## Valencia South JSP13-75 with Rezoning 18.706

Public hearing of the request of Beck South LLC for Planning Commission's recommendation to City Council for rezoning of property in Section 29, on the southwest corner of Beck Road and Ten Mile Road from R-1, One-Family Residential to R-3, One-Family Residential with a Planned Rezoning Overlay. The subject property is approximately 41.31 acres.

## PLAN REVIEW CENTER REPORT

**TO:** BARBARA MCBETH; COMMUNITY DEVELOPMENT  
**FROM:** JEREMY MILLER, E.I.T.; STAFF ENGINEER *JJM*  
**SUBJECT:** JSP13-0075 VALENCIA SOUTH CONCEPT PLAN UPDATES  
**DATE:** JANUARY 7, 2015

Figure 2. Wetland Delineation Map (Provided by King & MacGregor Environmental, Inc.)

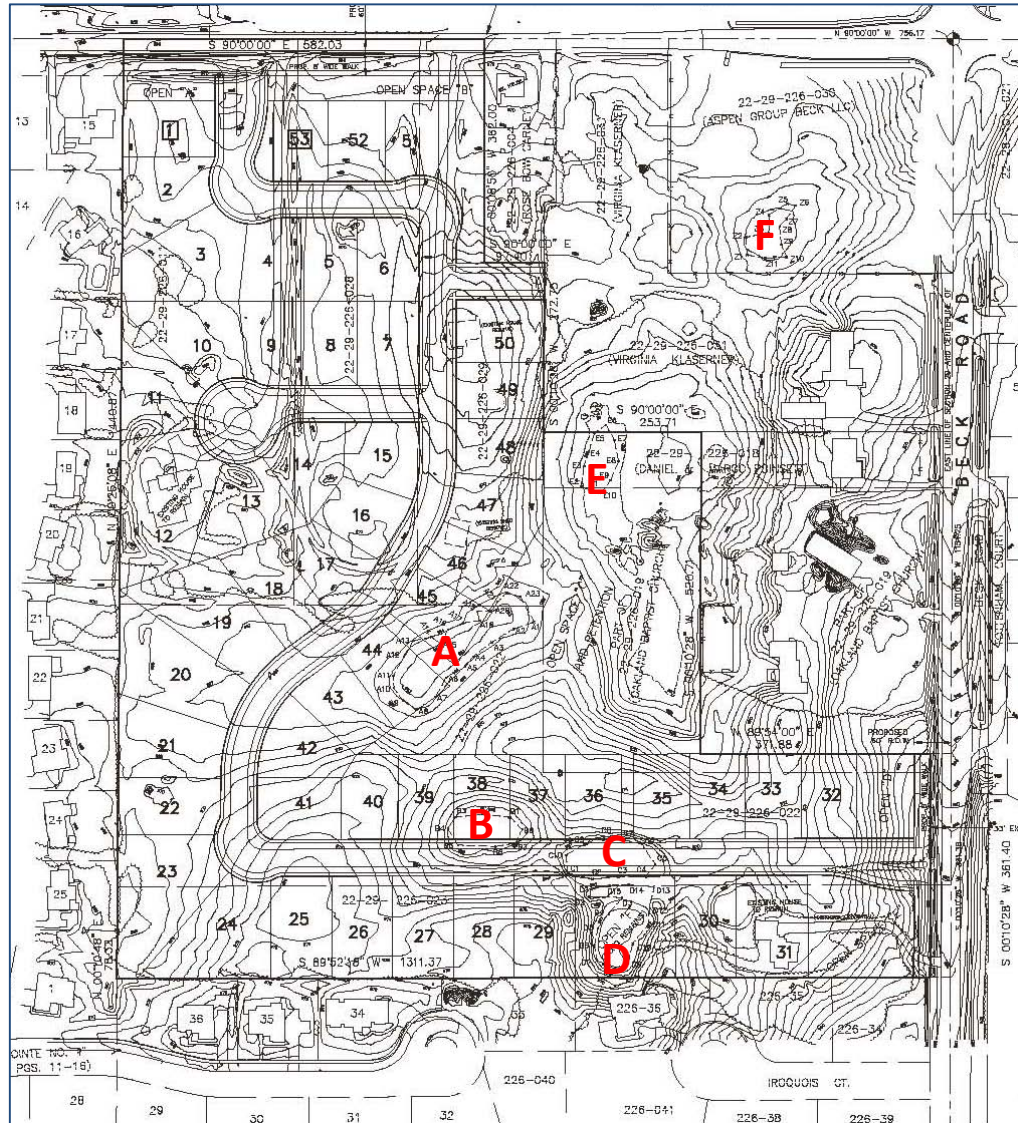
It is however, still unclear why some areas of wetland and wetland buffer cannot be preserved in the site development plan (i.e., impacts to Wetland F and its 25-foot setback as well as areas of the wetland setbacks of Wetland A and Wetland E).

The *Planned Rezoning Overlay Plan* (Sheet 2) indicates six (6) on-site wetland areas. These wetland areas were delineated by King & MacGregor Environmental, Inc.

The following table summarizes the existing wetlands and the proposed wetland impacts as listed on the *Planned Rezoning Overlay Plan* (Sheet 2):

Sketch Demonstrating the  
Increased Rear Yard Setback

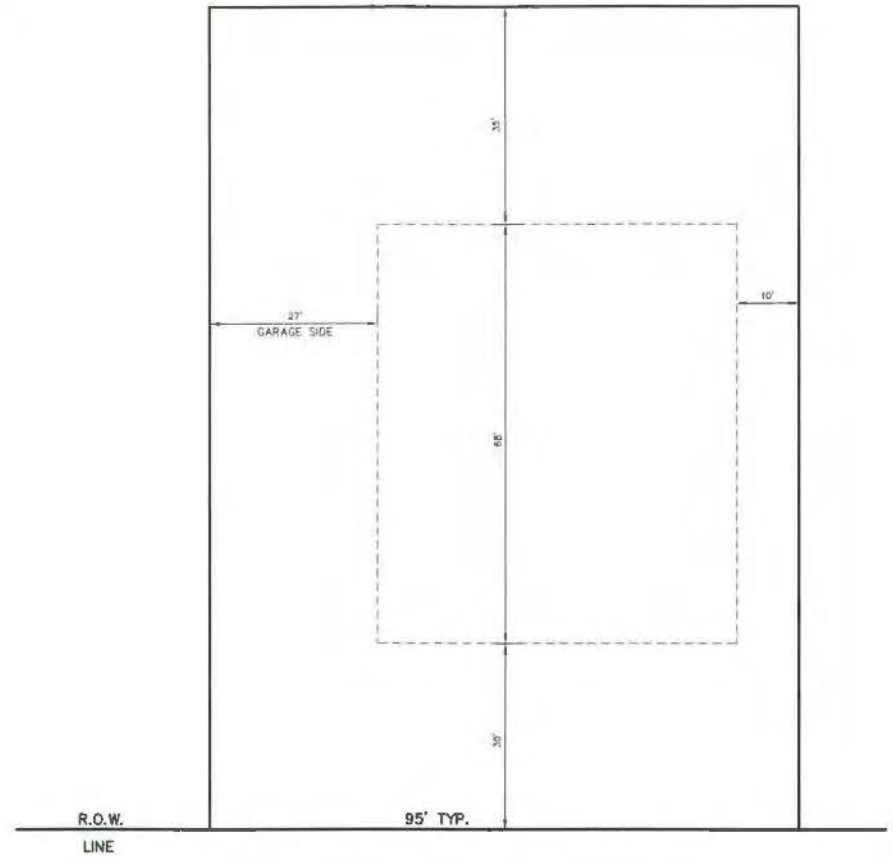
- a. Applicant must provide an increased rear yard setback of 50 ft. for Lots 19-30 and 43-46 consistent with the provided sketch;
- b. Applicant must provide a pathway connection to Ten Mile Road from the internal loop street as noted under Comment 1 of the engineering memo dated January 7, 2015;
- c. Applicant must provide a pathway stub to the south terminating north of the property line between lot 33 and 34 of Andover Pointe No. 2 as noted under Comment 2 of the engineering memo dated January 7, 2015;
- d. The findings of compliance with Ordinance standards in the staff and consultant review letters and the conditions and items listed in those letters begin addressed on the Preliminary Site Plan.
